# Te Raekaihau Point Restoration

feedback on draft landscape plan:  
Oct-Nov 2009

Car restrictions - Te Raekaihau Point draft landscape plan

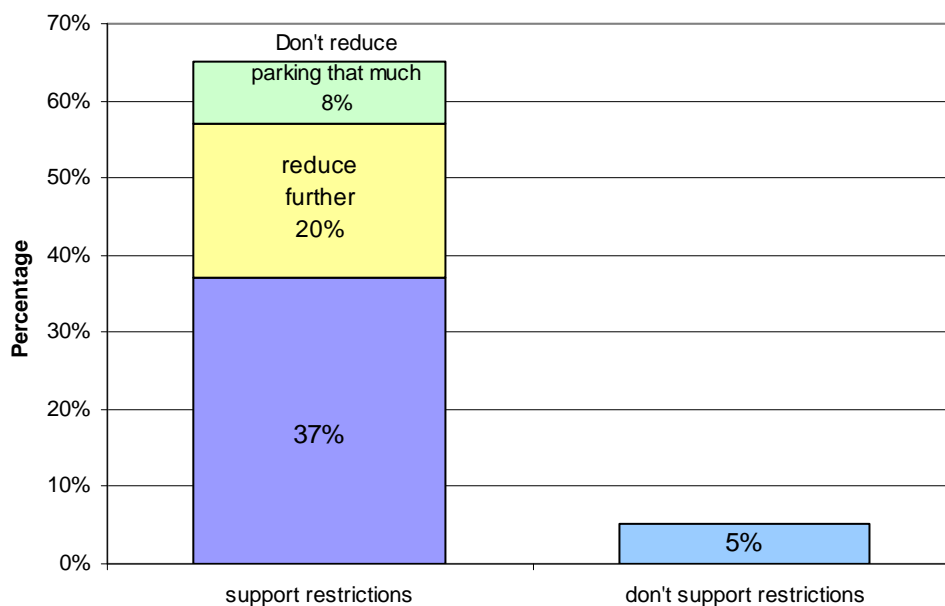
The majority of people supported the plans to reduce car-parking at this site. This will remove vehicles and assist ecological restoration. It will also make a safer environment for pedestrians and cyclists (28%).

A large portion wants to see the car-parking area reduced further (20%) as there is ample parking.

Others said this was the wrong thing to do. Viewing the coastal environment from cars is the main reason many people visit this site and this is an important feature of the south coast experience. Restricting car access will mean this experience will not be the same e.g. parking at tip of point not possible so can not get best views, carrying diving gear.

Some worried there was not enough parking and that this could result in congestion on busy summer days (9%). This could result in unsafe parking at the site and on the adjacent road – which is narrow and already considered unsafe.

Some wanted the car-parking area extended a bit to south of the 'island' to take advantage of the views.

Over 30% made comments on the entry and exits and one-way system. Many related to the current road being unsafe – especially for cyclists.

*“This corner (Lyal Bay side) has poor site lines and currently poor accessibility when accessing the site. Could not the access point be close to the Lyall Bay side on the point for safety purposes?”*

*“the inclusion of 'marked car parks' & the inclusion of planter areas 14 is in my view changing substantially the nature of the 'rough/wild' nature of the area”*

*“Vehicle barriers should be solid but not so high as to impose on views from people sitting in cars. Some cars are lower than others and the high barriers impede the view.”*

*“to enjoy the view from Cook Strait around towards the airport, cars need to be able to park towards the tip of the Point”*

### Recreation facilities - Te Raekaihau Point draft landscape plan

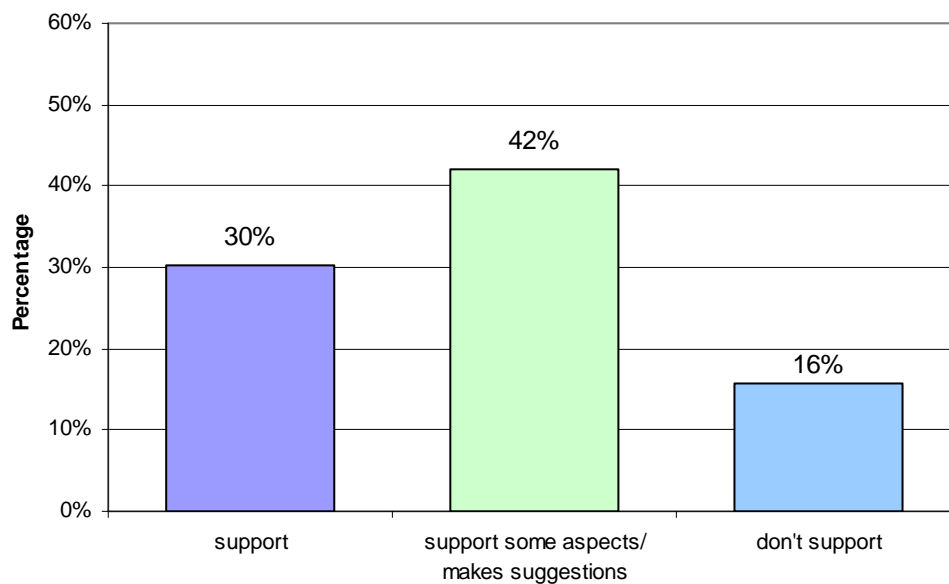
16% did not support the plans. The main reason provided was structures are not needed in this natural setting and are a waste of money.

There is some support for the track to the headland (16%), but residents note there are safety issues around crossing the busy road at a blind corner.

There was concern about the defined tracks around the point and that material would be introduced e.g. edging. 23% said there wasn't a need for a defined walkway south of the 'island'. A few said the track surface would need to be accessible for a number of users e.g. prams, wheelchairs.

Around 40% said that structures or formalising features (e.g. marked car-parks) were not appropriate at the site. The recent battle over the proposed Marine Education Centre and subsequent unique landscape ruling from the Environment Court were mentioned. People felt that the natural environment should be the centrepiece and not interrupted by built structures like planters, seats, edging on walkways, boulders, speed bumps.

The materials being proposed for the site were not seen as natural to the environment (25%).

*“The proposed compacted, gravel pathway winding through the site is unnecessary. This is a wild area on the South Coast and any attempt to urbanise it should be reduced.”*

*“We think improved access to the lookout is a great idea. Our concern is safety in obtaining access at 9 as the corner is very close and east bound traffic, downhill, moves very quickly. maybe warning notices could be placed appropriately and a speed restriction of 30kmh could be applied throughout the area”*

Coastal views - Te Raekaihau Point draft landscape plan

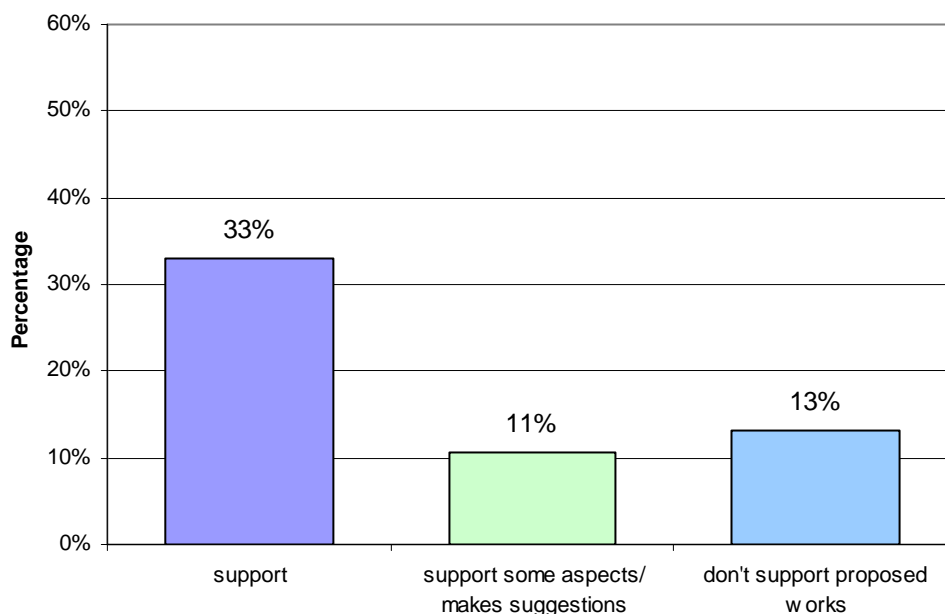
Over 30% supported the proposal for retaining coastal views. That is because it is important to retain the views from the point (11%) and especially views from cars (17%). That is why is important that no structures (19%) or plants (20%) block these coastal views.

There were mixed views about the raised area with 12% support, 12% opposed.

*“I would suggest that the angular parking in area 6 to 14 is the wrong direction to take advantage of the views”*

*“The long asphalted carparking area has nowhere near the same views as the shingled area on the point, so I strongly oppose confinement of parking to this area. Even if you raise it up, the views will not be nearly as awesome as the view from the point on a stormy day.”*

*“We are not very supportive of raising the level of the carpark to improve view. We believe this encourages to passive an interaction with the environment. We want visitors to get out of their cars and that the view are a reward for engaging with the environment”*

**Ecological restoration - Te Raekaihau Point draft landscape plan**

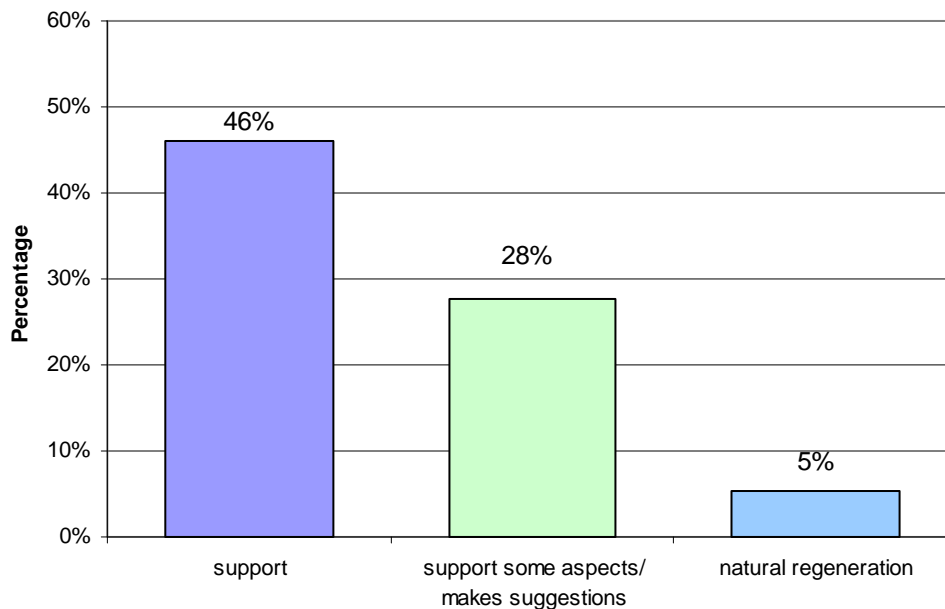
There was a lot of support for ecological restoration and many made suggestions including wanting the area being restored to be increased e.g. 20% wanted to reduce parking further to enable more area to be vegetated. Others thought the restoration area should include the headland behind the point (7%) and dunes in Princess Bay (5%). A few said all areas should be restored and there should be no landscape planting.

- Using eco-sourced coastal plants (25%)
- Using low growing plants that will not block views (20%)
- Having ongoing pest and weed control (21%)
- This not becoming a 'garden' (16%)

- Incorporating habitat for penguins (13%) and other animals (5%) and reducing the threats from vehicles and pest species
- Involving community in ecological restoration (4%)

Some question what was being restored (5%). Area only emerged in 1855 earthquake. A few questioned if introducing threatened species not known from the south coast was a good idea.
